Sharktooth Bluffs Basin Storm Drainage Master Plan September 2019

RE: Sharktooth Bluffs Basin Storm Drainage Master Plan

ICON Engineering, Inc. is pleased to submit the Final Conceptual Design Report for the Sharktooth Bluffs Storm Drainage Master Plan. This submittal includes revisions to the report based on comments received on the DRAFT Conceptual Design Report.

Sharktooth Bluffs Basin Masterplan								
Comment and Response Tracking								
Draft Baseline H+H Report								
No.	YOUR NAME (last name, first name)	SECTION #	PAGE	LINE	COMMENT	S, R, E (Substantive, Requested, Editorial)	A, R, C (Accepted, Rejected with explanation, Needs Clarification)	RESPONSE (by consultant)
27	Fisher, Andrew	Study Area Map	7	Figure 2.1	Please add Long Range Growth boundary to map as well, if it can be depicted clearly. This may require a Study Area Map for present day boundaries and a separate map for future forecasted boundaries.	R		A vicinity map was added to show the LRG boundary in relationship to the Sharktooth Bluffs Boundary
28	Fisher, Andrew	Subwatershed Map	8	Figure 2.2	Please increase the size of Tributary labels to the size of the Jones Ditch and No.3 canal at minimum	R		Size has be

Figure 4.6 - FLO-2D Hazard ID -
Baseline - 100-Year

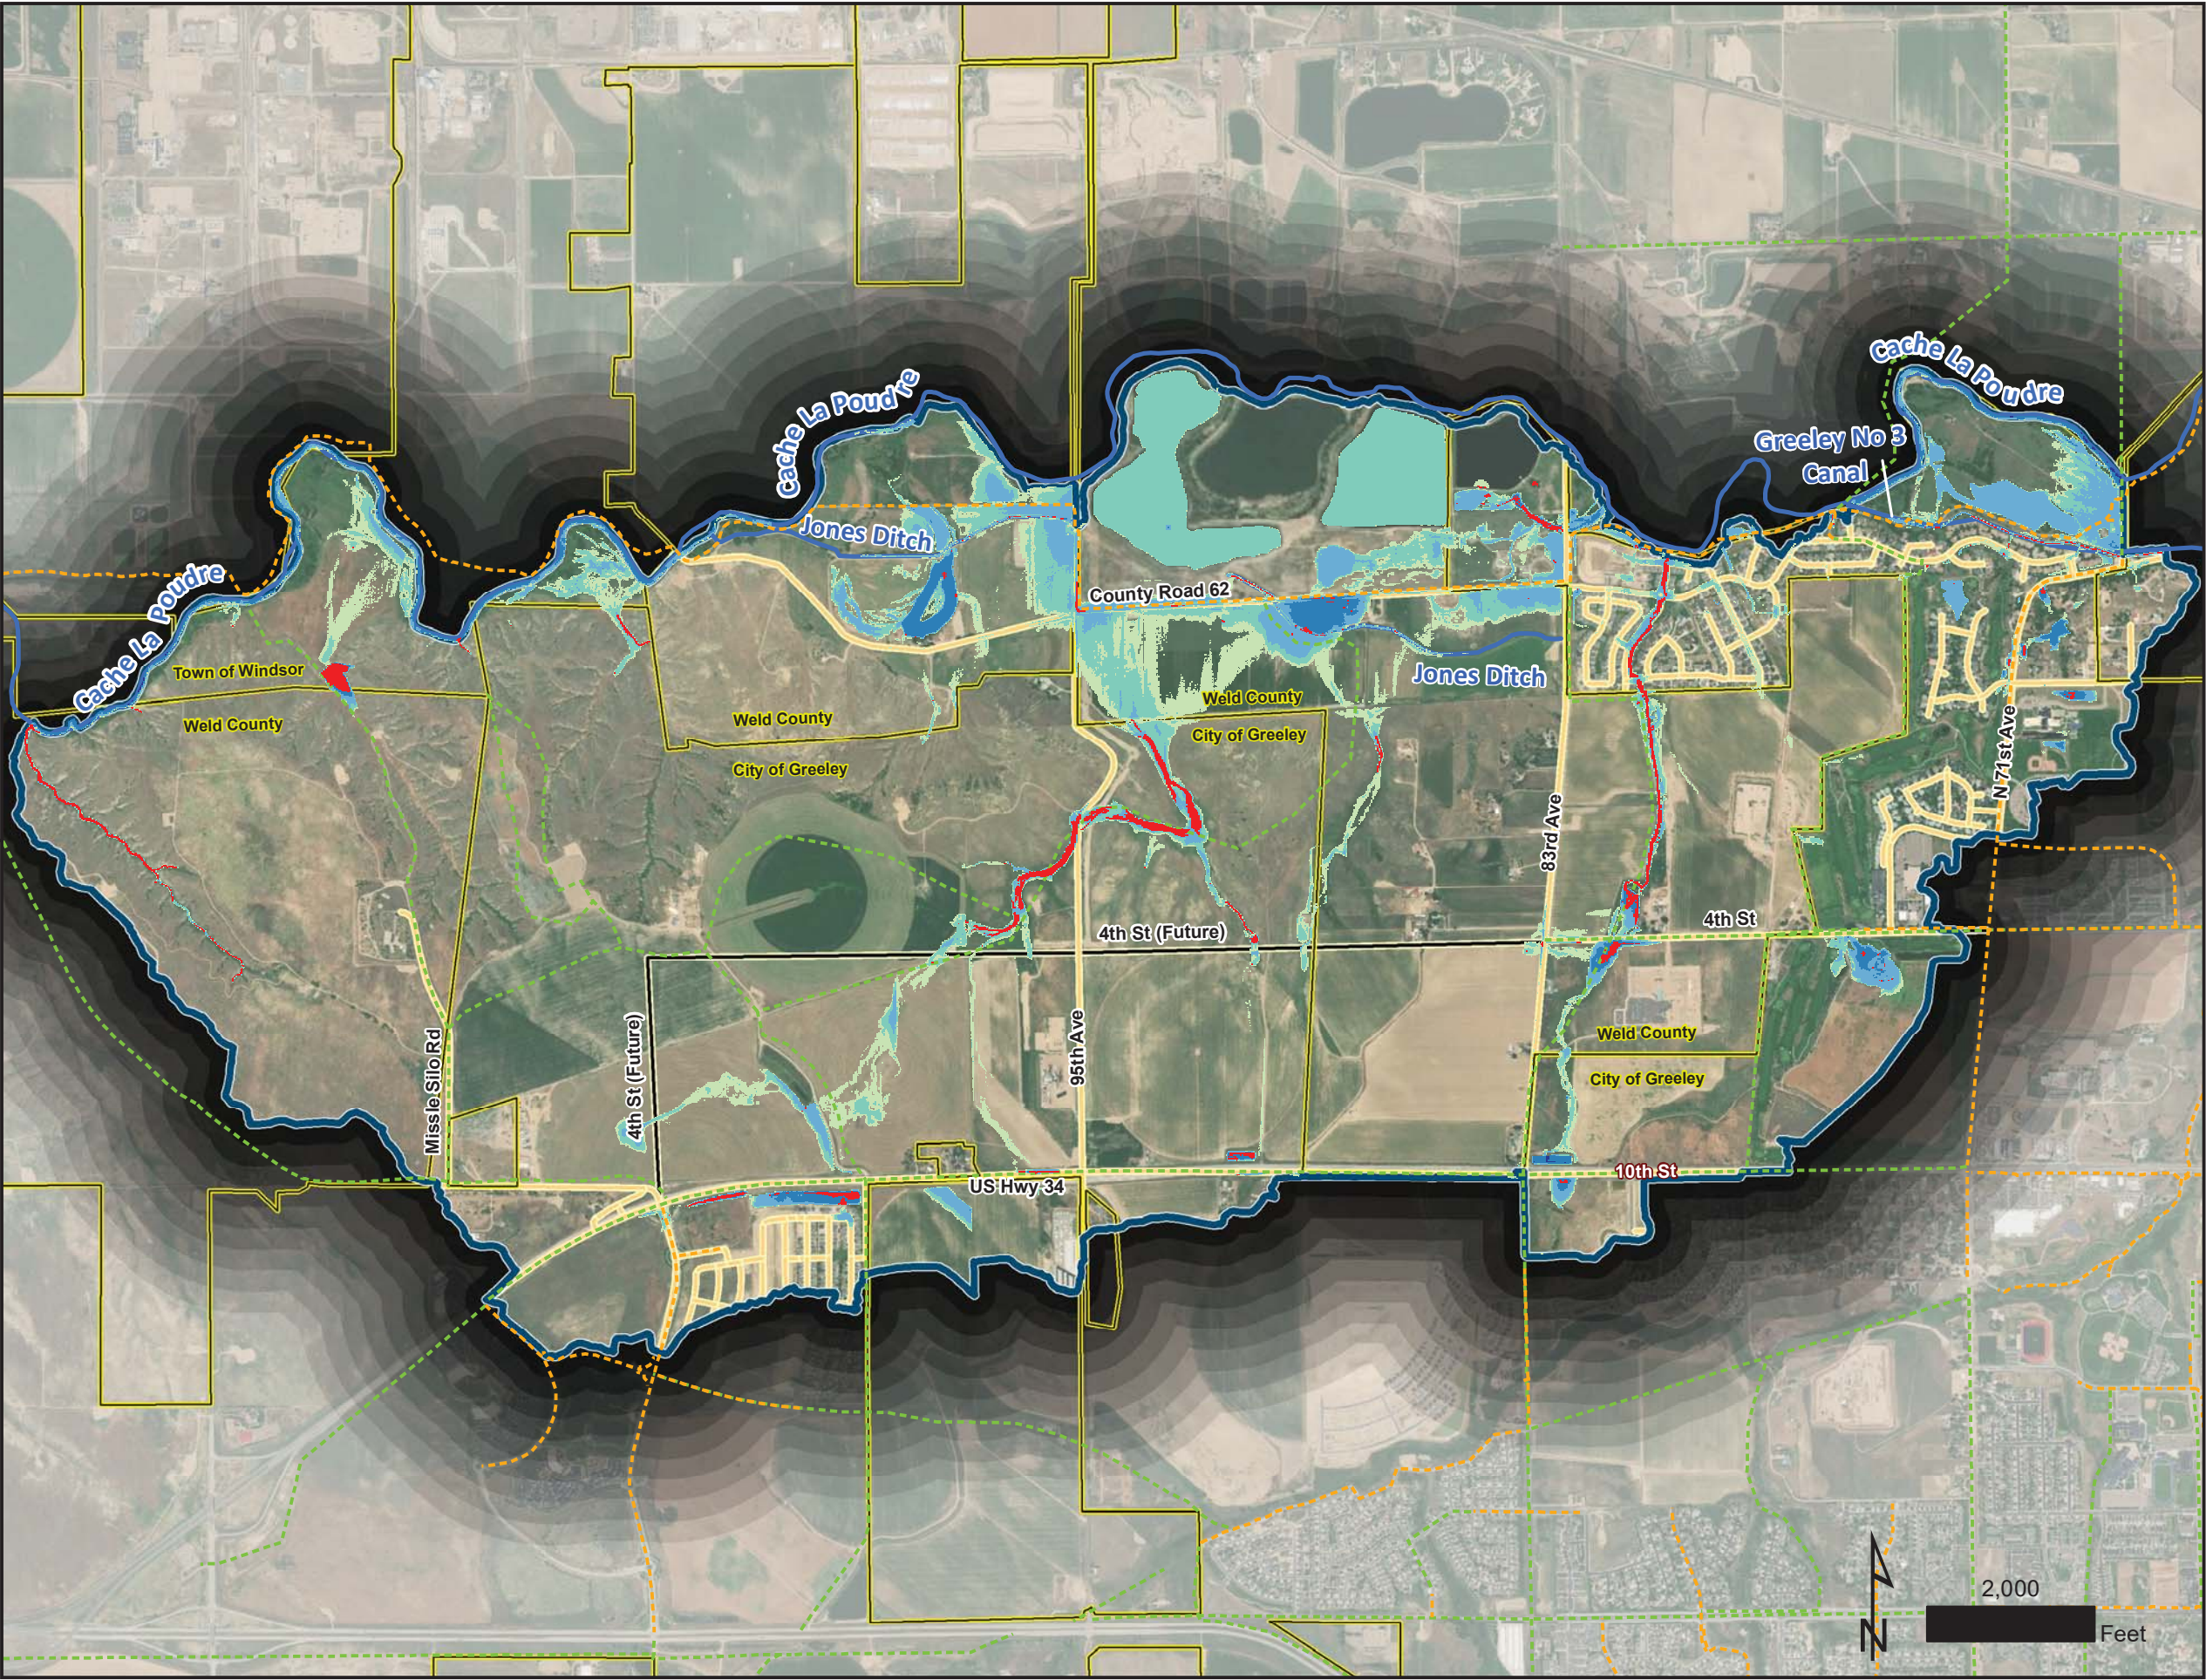
29	Fisher, Andrew	4	37-38	Fig 4.5/4.6	High hazard designations at end of Spur Draw, Missile, Hertzke and near 71st Ave. I presume this is a result of boundary condition and that there isn't specifically a high hazard adjacent to the river? Can this be edited out?	R	A	High hazard designations have been revised
30	Fisher, Andrew	5	48	5.7	Why is a BCA completed for 81st Avenue alone?	S	A	See comment 16. No other projects provided mitigation benefits to justify a BCA being completed
31	Fisher, Andrew	5	49	5.8.3	It may be helpful to have an exhibit showing the extent of the drainageway reaches	R	A	Figure 7.3 has been added to the report
32	Fisher, Andrew	6	54	6.1	As development continues, stream buffer width needs decrease. Do you have recommendations for how to manage the decreased needs with increased development?	S	A	A recommendation threshold of 80 percent has been included in the report. Once the threshold is exceeded the buffer widths could be reduced

Figure 6.1 - Recommended Plan - Sharktooth Draw and Poudre Learning Center

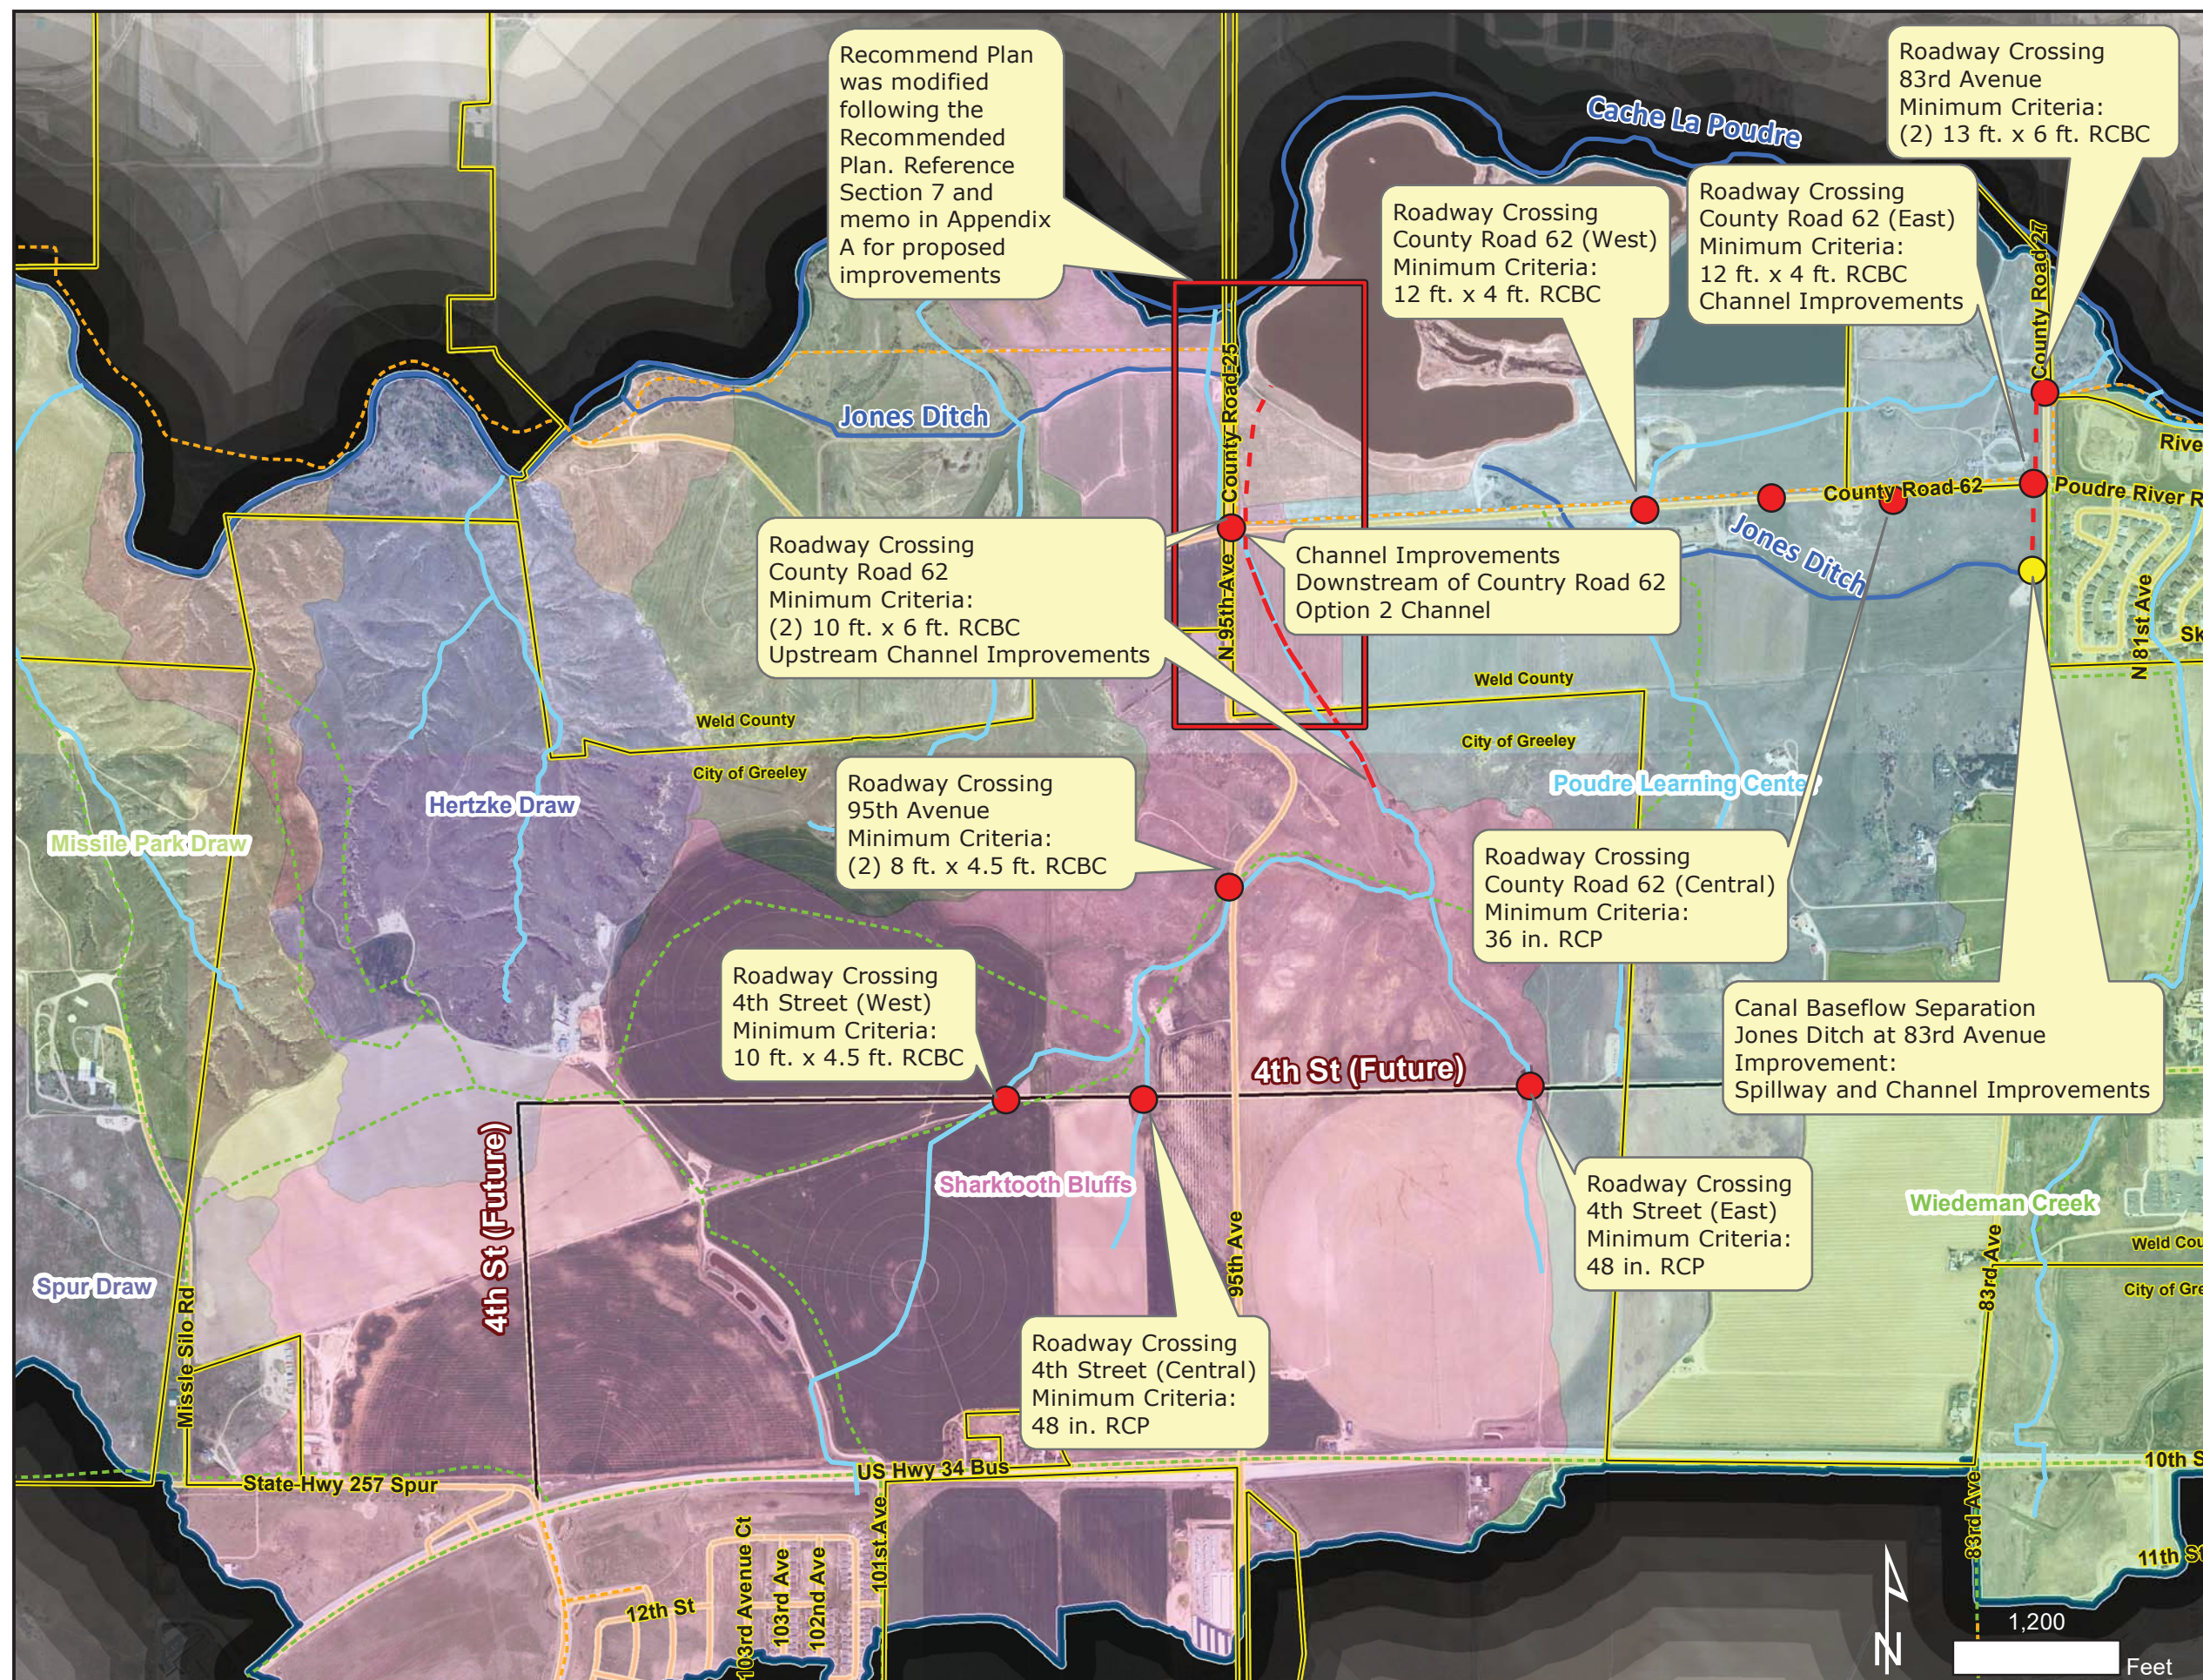
33	Fisher, Andrew	6	55	Table 6-1	78th Aveue has No Action and minimum Criteria Alternatives selected. Please clarify.	E	A	Table has been revised
34	Fisher, Andrew	6	58	Figure 6-1	Figure reflects recommendations from initial Alt Analysis. Please update with final recommended plans	S	A	Figure has been revised
35	Fisher, Andrew	7	60	7.1.1	Typo	E	A	Report revised
36	Fisher, Andrew	7	78	7.2.7.4	Please ensure all mentions of street are "Amour Hill Drive"	E	A	Report revised
37	Fisher, Andrew	7	78	7.2.7.4	"relying" should bwe "relaying"	E	A	Report revised
38	Fisher, Andrew	7	78	7.2.7.4	What is the existing slope of the 30" RCP?	R	A	The existing pipe at 0% slope was determined from survey which was verified.
39	Fisher, Andrew	7	78	Table 7-15	Wiedeman misspelled on Table 7-15	E	A	Report revised
40	Fisher, Andrew	7	87		As development continues, stream buffer width needs decrease. Do you have recommendations for how to manage the decreased needs with increased development?	S	A	See comment 32
